EASTERN CORRIDOR SEGMENTS II AND III (PID 86461)  
**COMBINED LINWOOD/EASTERN INTERCHANGE AND US 50/RED BANK INTERCHANGE FOCUS AREA**  
**ADVISORY COMMITTEE MEETING #2**  
R.G. CRIBBET RECREATION CENTER • MAY 22, 2018

## MEETING #2 NOTES

**Figure I-26A & I-27A**  
**ROUNDBOUTS AT BEECHMONT CIRCLE INTERSECTIONS WITH WILMER AVENUE AND WOOSTER ROAD**

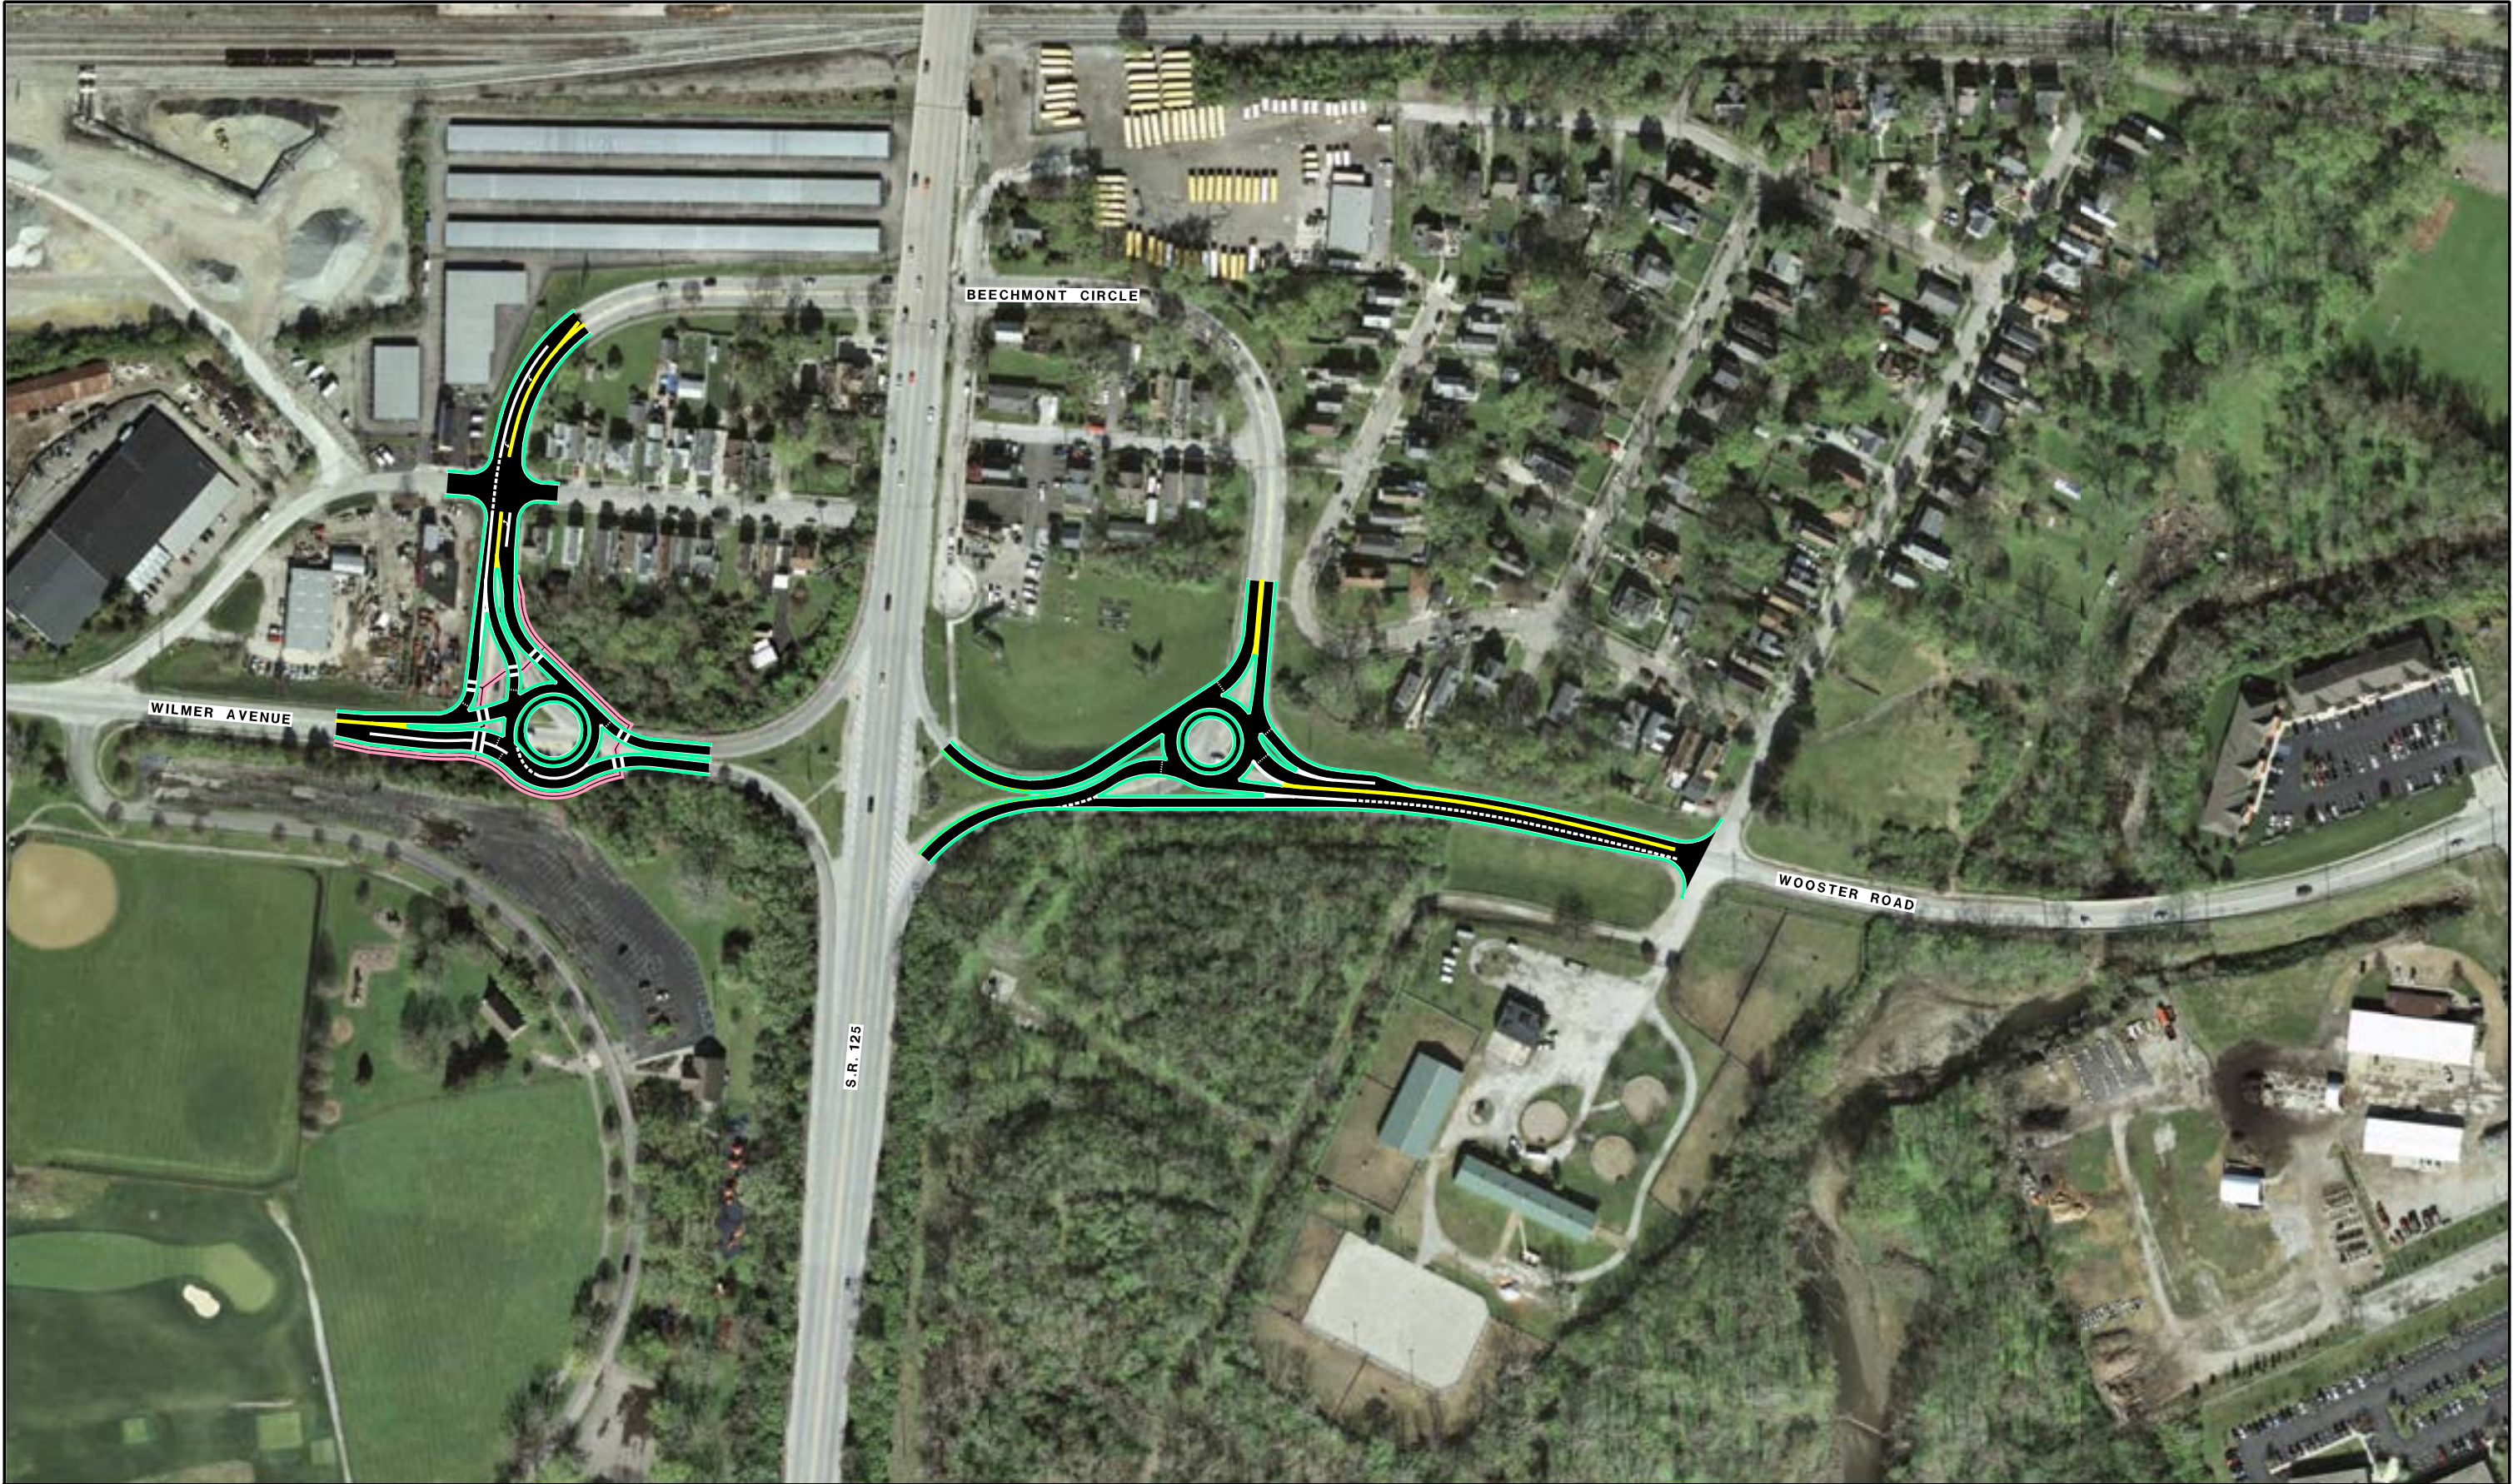
- Roundabouts help calm traffic and facilitate U-turns.
- Proposed modifications are smaller in scale than those proposed for other concepts.
- The roundabout would reduce delays by:
  - 57% during morning peak-hours
  - 11% during evening peak-hours

- Roundabouts help calm traffic and facilitate U-turns.
- Proposed modifications are smaller in scale than those proposed for other concepts.
- The roundabout would reduce delays by:
  - 57% during morning peak-hours
  - 11% during evening peak-hours

**Figure I-20B**  
**ROUNDBOUT AT WOOSTER PIKE**  
**AND RED BANK ROAD INTERSECTION**

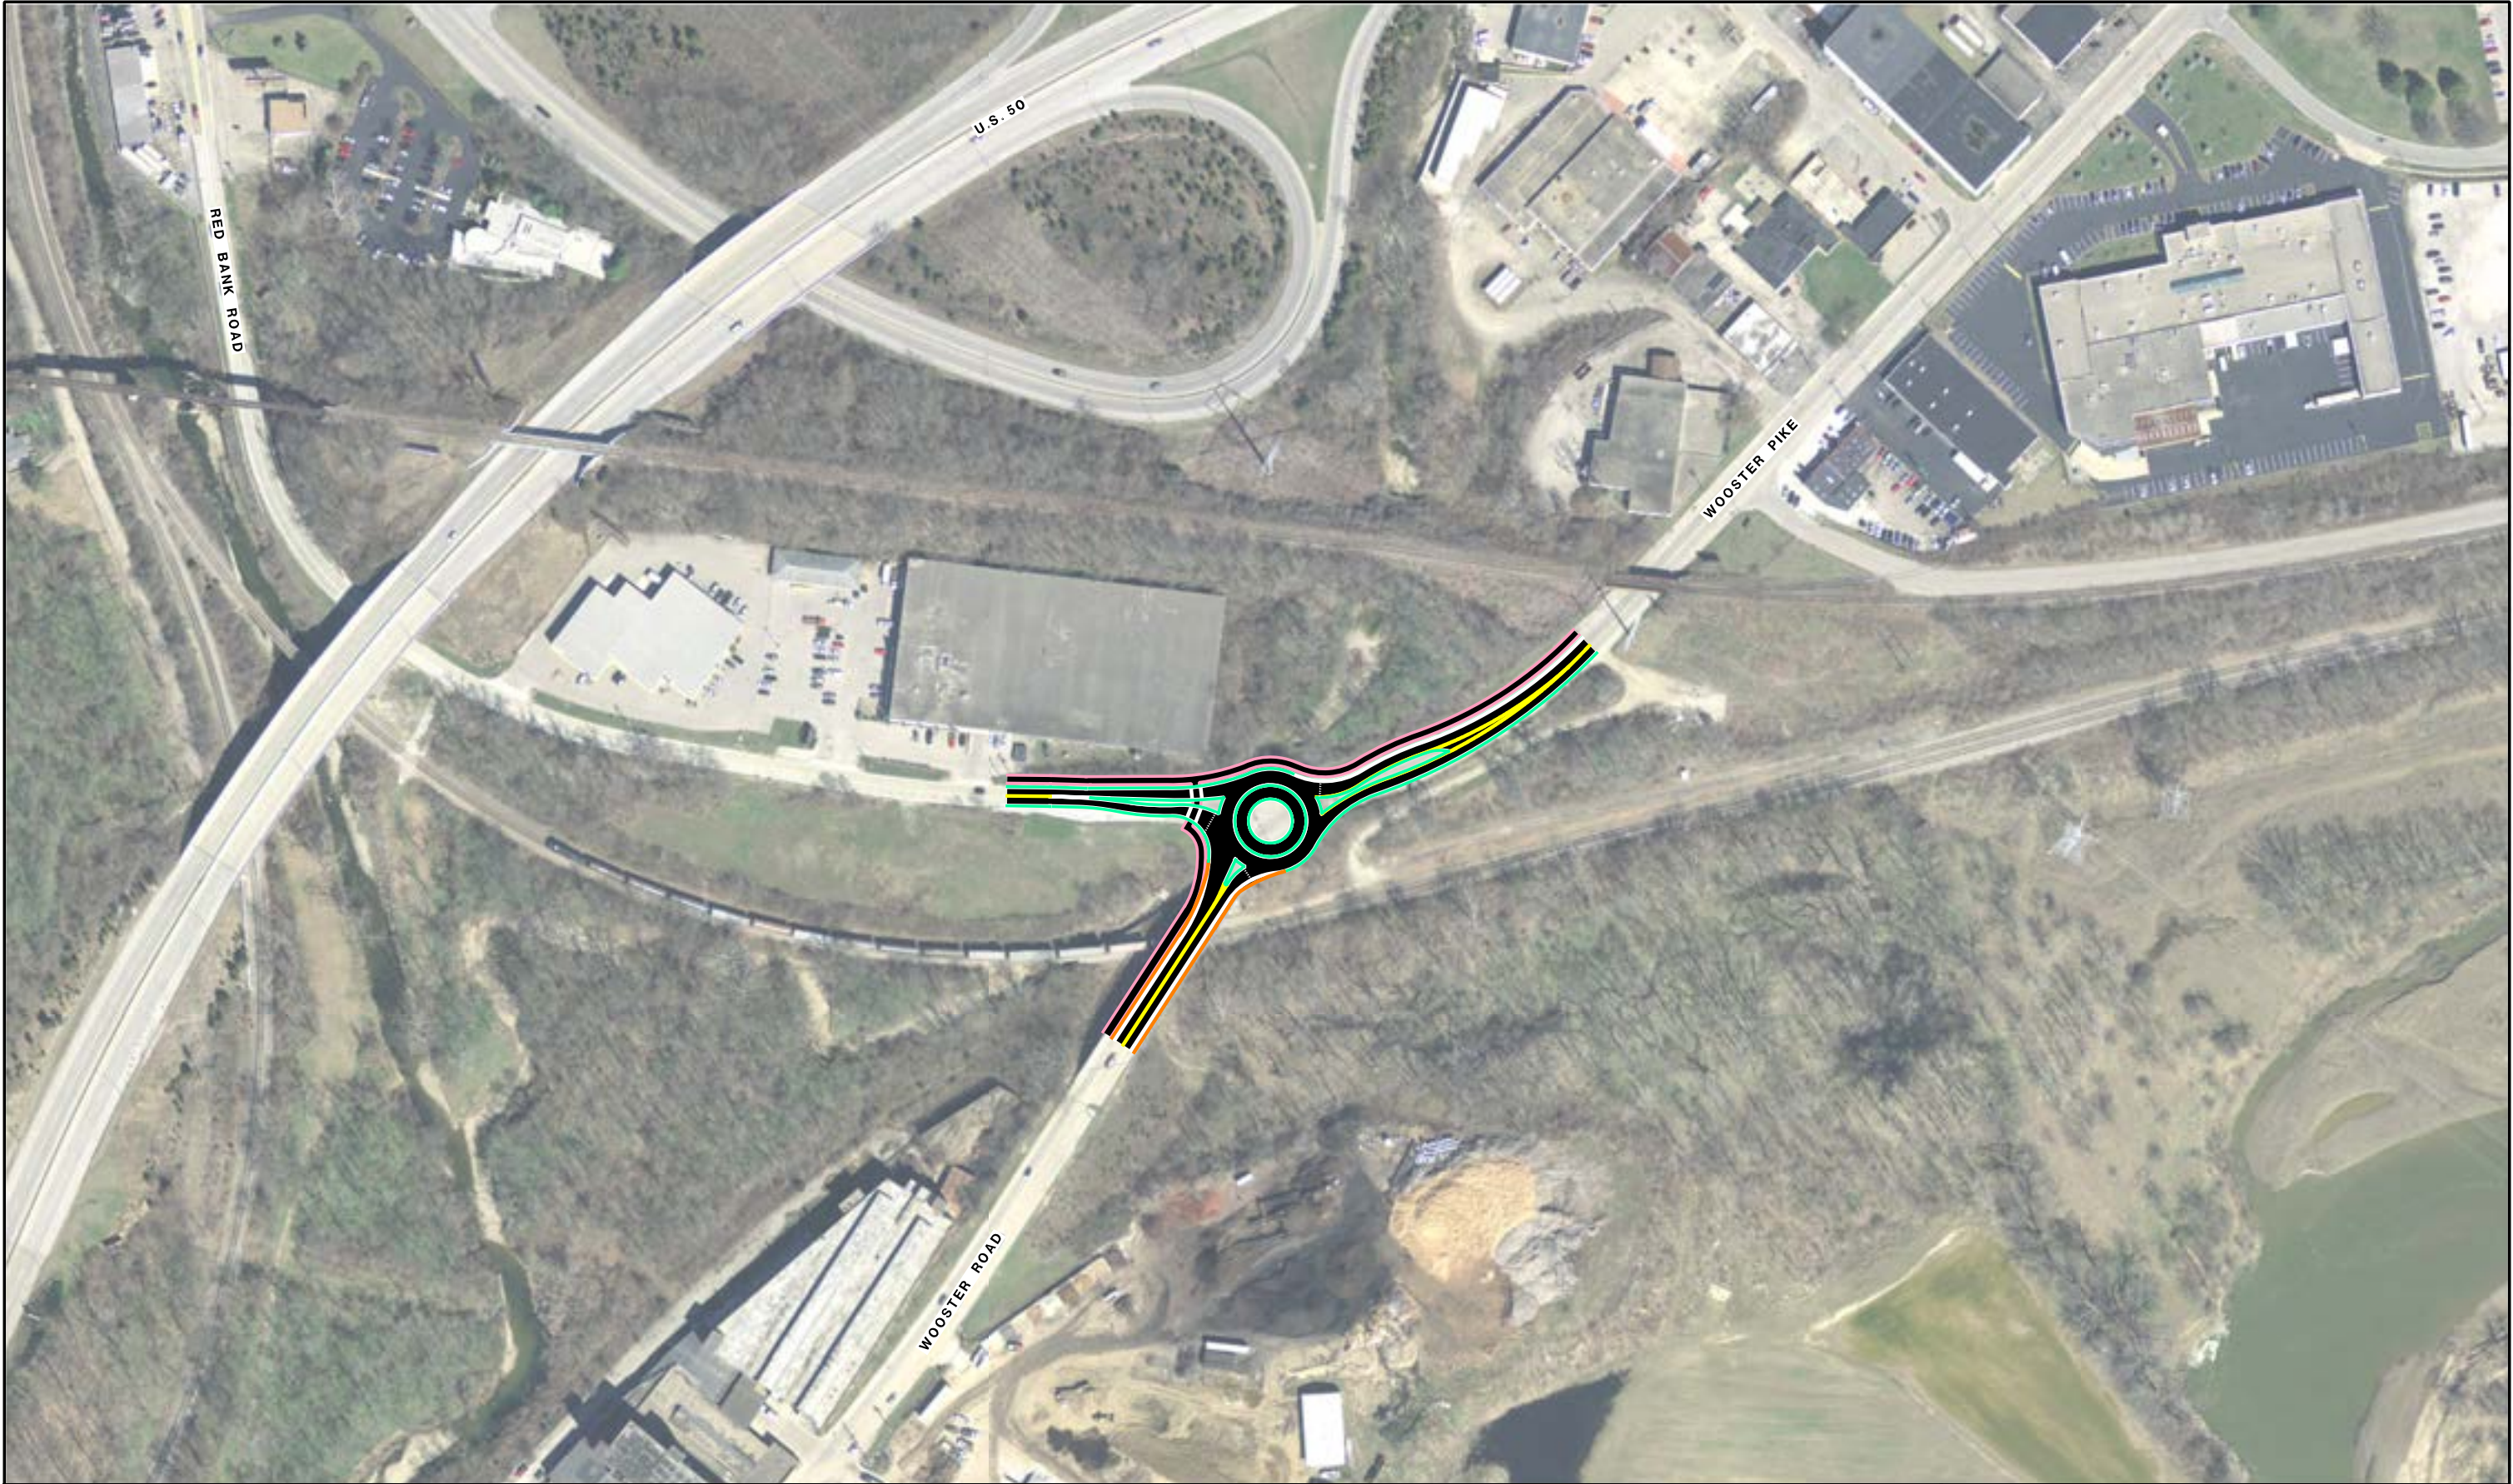
- A roundabout would be designed to comfortably accommodate trucks.
- Only need to use two lanes instead of three on the bridge, and it would be possible to get a bike lane across the bridge over the railroad without widening the existing bridge.
- Initial analysis indicates:
  - No change in delays during morning peak-hours.
  - A 20 percent increase in delays during evening peak-hours.
- Team will consider how best to incorporate multi-use path connections into this concept.
